County of Fairfax, Virginia

Re: Interpretation for RZ/FDP 2002-HM-043, Arrowbrooke Centre, Tax Map 16-3 ((1)) 39A4: Site Modifications

ADMINISTRATIVE INTERPRETATION GRAPHIC

**ADMINISTRATIVE
 INTERPRETATION
 GRAPHIC**

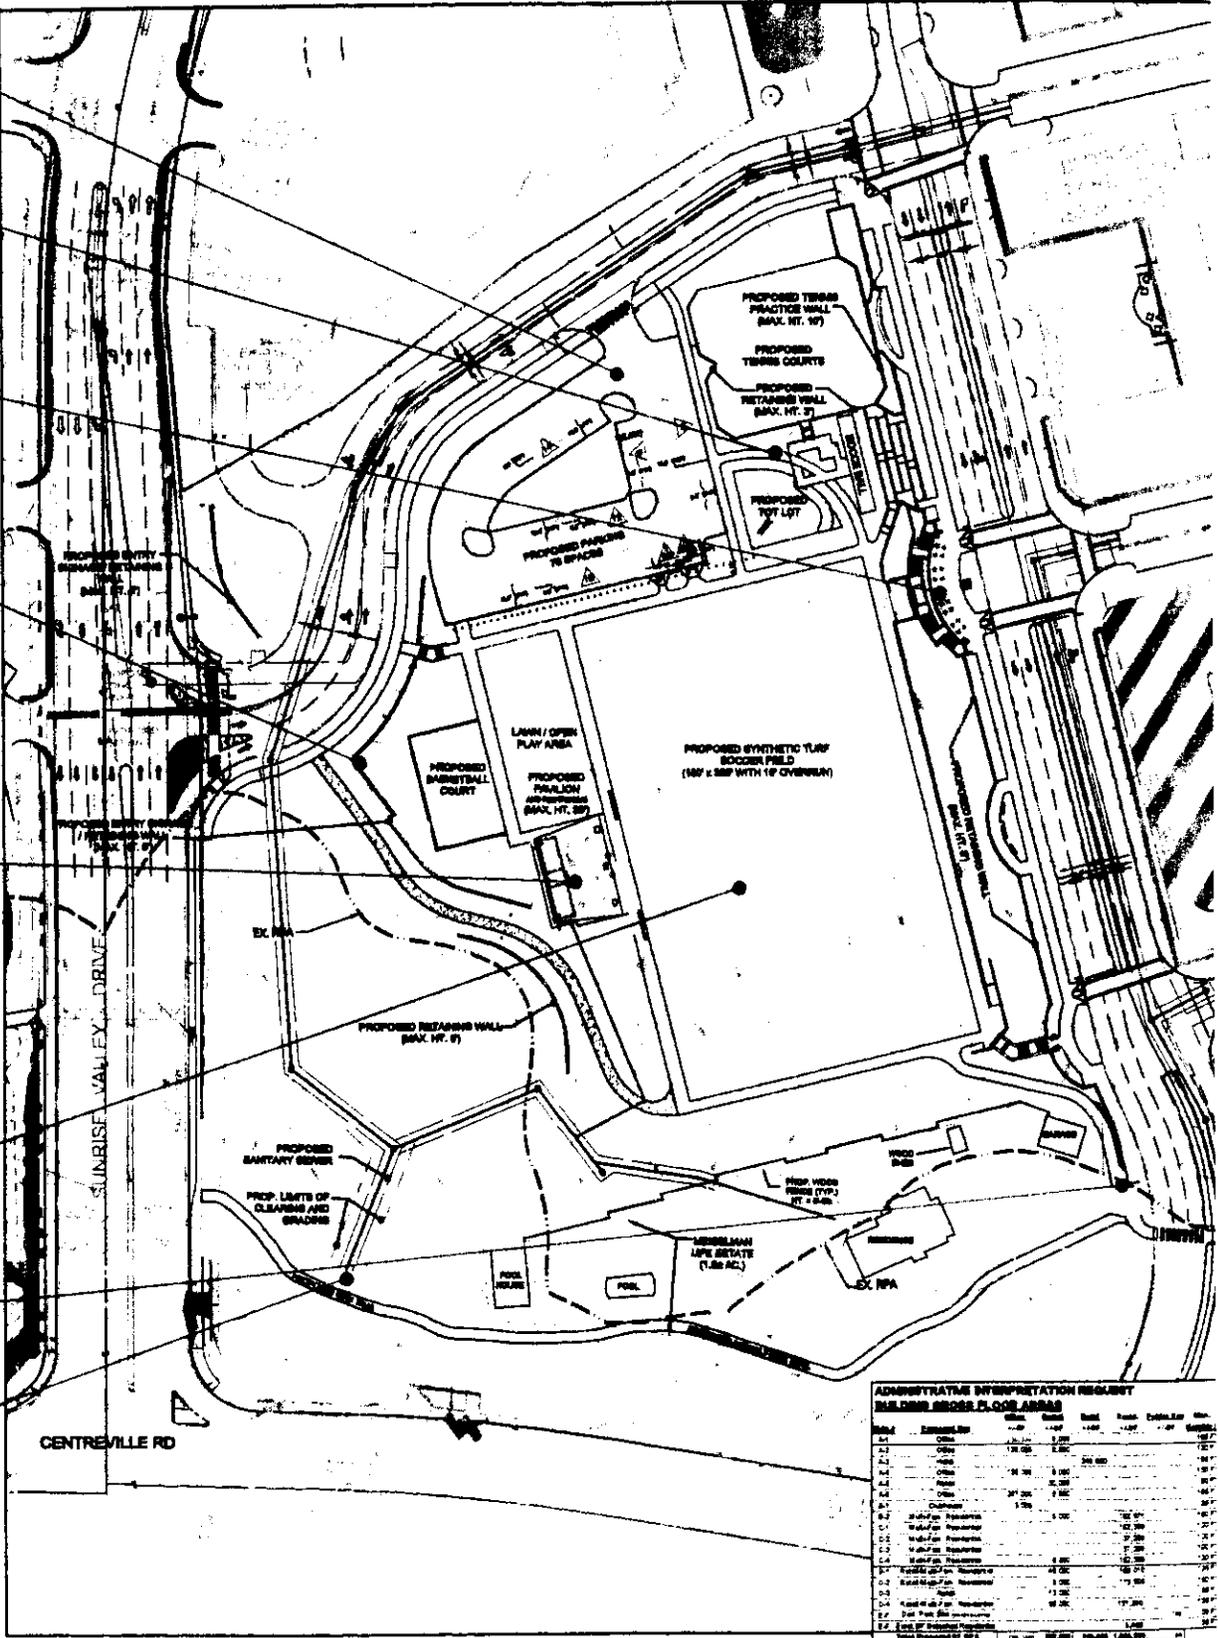
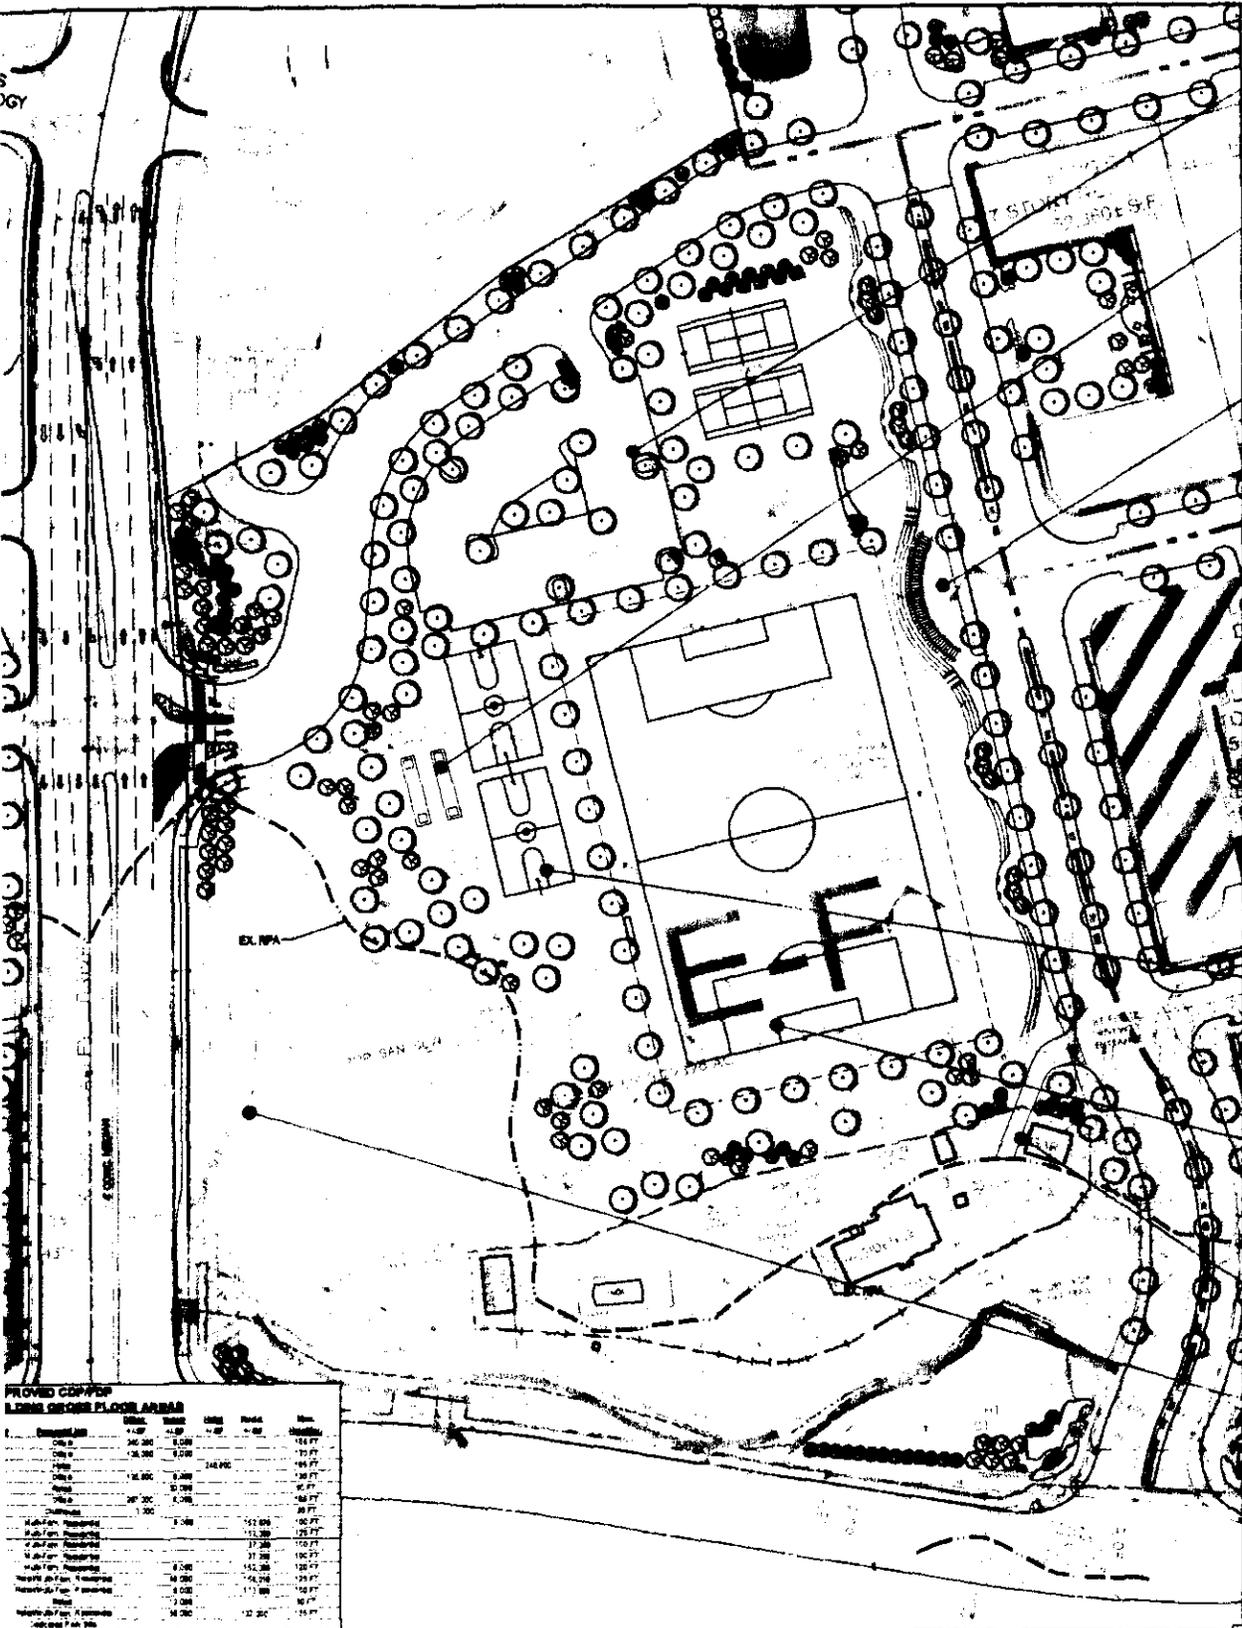
The first question (A) is whether the proposed reconfiguration of the parking lot is in substantial conformance with the proffers, the CDP/FDP, and the development conditions. You indicate that the parking lot will remain in the same general location and configuration as that shown on the CDP/FDP and that there will be no reduction in the number of parking spaces. You state that the change is being proposed to address sight distance issues caused by vehicle parking along the site frontage where there is a curve in the road. The interpretation graphic shows that the main modification proposed to the parking lot is the relocation of parking spaces from along the front of the site to the interior of the lot. The parking lot island has been increased in size. No change to the access is proposed.

The second question (B) is whether the substitution of a bocci ball court for two horseshoe pits would be in substantial conformance with the proffers, the CDP/FDP and the development conditions. Your letter states that FCPA was in agreement with you that horseshoe pits were not the best activity and could be dangerous. The CDP/FDP shows two horseshoe pits located in an open play area on the west side of two basketball courts. You are proposing to eliminate the horseshoe pits and to build a bocci ball court on the north side of the site adjacent to the two tennis courts and in close proximity to the proposed tot lot. Your letter cites Proffer 30A, which states in part that *"The Applicant or its successors-in-interest and/or assigns, reserves the right to modify the park land design as may be necessary with final engineering for Land Bays E-F and G and to revise secondary facilities, add trails, picnic facilities, and other similar park facilities on Land Bays E-F and G, without the requirement for a FDPA if approved by FCPA and otherwise in general conformance with the CDP/FDP."* As noted in the attached letter from Sandy Stallman, the FCPA supports the proposed design.

The third question (C) is whether the proposed modifications to the streetscape and community stage are in substantial conformance with the proffers, the CDP/FDP, and the development conditions. Your letter states that final engineering has determined that there is more of a grade difference between the park area and the proposed road along its northern border. As a result you are proposing the addition of one (1) continuous retaining wall with a maximum height of approximately eight (8) feet along the northern side of the site. Based on your exhibit, the retaining wall will extend along the entire northern edge of the park. It would contain curvilinear elements to accommodate the community stage to provide overlook areas with landscaping and benches. The maximum height of the wall is ten (10) feet which occurs adjacent to the tennis courts where the wall is proposed to serve as a "practice wall." You state that the proposed design also provides a ramp to provide ADA access near the tot lot and bocci ball court. The curvilinear seating element that was provided along the northern edge of the park on the CDP/FDP would be eliminated in the proposed design because of the grades; however, a sloping grass lawn located between the retaining wall and the proposed soccer field

The fourth question (D) is whether the addition of retaining walls on the eastern and western sides of the entry road from Sunrise Valley Drive and modifications to the landscape plan in that area would be in substantial conformance with the proffers, the CDP/FDP, and the development conditions. The proposed maximum height of the walls is six (6) feet. You state that the walls are needed to retain grade and to provide the flat areas needed for the soccer field, open play area, and basketball court. You state that the walls would also be used for signage and an entry feature for the development. The submitted Exhibit 2A shows the Sunrise Valley Drive entrance and landscaping that was approved on the CDP/FDP. There were no retaining walls. The proposed landscaping for the entrance area is depicted on your Exhibit 2B and shows the proposed approximately fifty foot long western retaining wall designed as an entry feature with landscaping provided on both sides of the wall. Five (5) street trees are shown adjacent to the entrance road consistent with the CDP/FDP and two (2) additional street trees are proposed at the site entrance. The retaining wall proposed along the eastern side of the entrance extends for approximately 260 feet. The landscaping adjacent to this wall has been increased, particularly as it concerns evergreen trees, in order to screen the basketball court and fenced enclosure from the road. The basketball court is proposed to be relocated closer to the road pursuant to Item F in this letter; therefore, the additional need for screening has arisen.

The fifth question (E) is whether the proposed enlargement of the picnic pavilion in order to accommodate 700 square feet of restroom space would be in substantial conformance with the proffers, the CDP/FDP, and the development conditions. As I understand it, the CDP/FDP did not provide for restroom space on the park site and the FCPA has requested that they be provided. You state that in order to compensate for the addition of GFA to this land bay Office Building A-1 will be decreased in size by approximately 700 square feet. Exhibit 1 contains a table with Office Building A-1 shown with 239,300 square feet of gross floor area versus 240,000 square feet of gross floor area as

The sixth question (F) is whether the elimination of one of the two basketball courts and creation of an open play area would be in substantial conformance with the proffers, the CDP/FDP, and the development conditions. As I understand, the FCPA agreed that the area was too constrained for two basketball courts and stated that their needs assessment did not support two courts. You have proposed to shift the one basketball court toward the south and away from the soccer field in order to create an expanded lawn area where the second basketball was located. You state that the proposed change allows the integration of the picnic pavilion into the park's design. Based on Exhibit 1, it appears that the proposed design will be a functional improvement over the original design. As noted earlier, Proffer 30 (A) permits the Applicant to, among other things, *".... to modify the park land design as may be necessary with final engineering for Land Bays E- F and G and to revise secondary facilities, add trails, picnic facilities, and other similar park facilities on Land Bays E-F and G, without the requirement for a FDPA if approved by FCPA and otherwise in general conformance with the CDP/FDP."*

The eighth question (G) is whether the proposed modification to the soccer field dimensions as requested by the FCPA would be in substantial conformance with the proffers, the CDP/FDP, and the development conditions. The approved CDP/FDP showed a field 195 feet wide by 300 feet in length. You state that FCPA staff has requested that the field be increased in length. You are now proposing a soccer field that measures 180 feet wide and 320 feet long with 15 foot overrun areas. You note that this change along with all of the listed modifications was approved by FCPA.

The ninth question (H) is whether the shift in location of the driveway access to the life estate would be in substantial conformance with the proffers, the CDP/FDP, and the development conditions. The current driveway to the life estate residence and that shown on the CDP/FDP is located north of the residence where you are now proposing to construct a retaining wall. You propose to relocate the driveway toward the east so that it would access the life estate property in a location that you state has safer driveway grades and geometry. You also state that the owner/occupants of the residence have reviewed and approved the proposed driveway location. It is my determination that the proposed relocation of the driveway to the life estate property is in substantial conformance with the proffers, the CDP/FDP, and the development conditions.

The tenth question (I) is whether the proposed re-alignment of a sanitary sewer line in the southeastern portion of the park area would be in substantial conformance with the proffers, the CDP/FDP, and the development conditions. You state that the proposed revision is the result of final engineering and the location of the tie-in to the existing trunk sewer. The approved CDP/FDP showed the proposed sanitary sewer in the southwest area of the site cutting through a narrow strip of trees to be preserved. You are now proposing to construct the sanitary sewer line further toward the east also through a larger area of existing trees to be preserved. Proffer 18C states that *"If as a result of final engineering, the areas designated as tree save areas on the CDP/FDP are modified or cannot be preserved, equivalent tree save areas or equivalent landscaped areas shall be substituted on the Property, as determined by Urban Forest Management"*. According to Exhibit 3A, the amount of clearing through a tree preservation area shown on the CDP/FDP was 2,500 square feet. You are proposing to reforest 2,650 square feet both within and outside the easement. Exhibit 3B shows the 25-foot wide reforestation area that consists of native deciduous and evergreen trees within the cleared area and proposed native shrubs across the cleared area and within the easement. Exhibit 3A also shows the proposed addition of supplemental landscaping between the easement and Sunrise Valley Drive to screen the easement.

It is my determination that the proposed modification to the parking lot is in substantial conformance with the proffers, the CDP/FDP, and the development conditions.

It is my determination that the proposed substitution of a bocci ball court for two horseshoe pits as described above is in substantial conformance with the proffers, the CDP/FDP, and the development conditions.

It is my determination that the proposed modifications to the streetscape and community stage area discussed above are in substantial conformance with the proffers, the CDP/FDP, and the development conditions.

As such, it is my determination that the proposed retaining walls and modifications to the landscaping at the Sunrise Valley Drive entrance to the site discussed above would be in substantial conformance with the proffers, the CDP/FDP, and the development conditions, subject to Urban Forest Management (UFM) approval of the revised landscape plan.

It is my determination that addition of 700 square feet of restroom space and the 700 square foot reduction of gross floor area in Office Building A-1 discussed above would be in substantial conformance with the proffers, the CDP/FDP, and the development conditions.

It is my determination that the elimination of one basketball court and an increase in open play area discussed above is in substantial conformance with the proffers, the CDP/FDP, and the development conditions.

It is my determination that the modifications to the size of the soccer field described above are in substantial conformance with the proffers, the CDP/FDP, and the development conditions.

It is my determination that the proposed re-alignment of the sanitary sewer line with reforestation and supplemental landscaping discussed above is in substantial conformance with the proffers, the CDP/FDP, and the development conditions, subject to Urban Forest Management (UFM) approval.
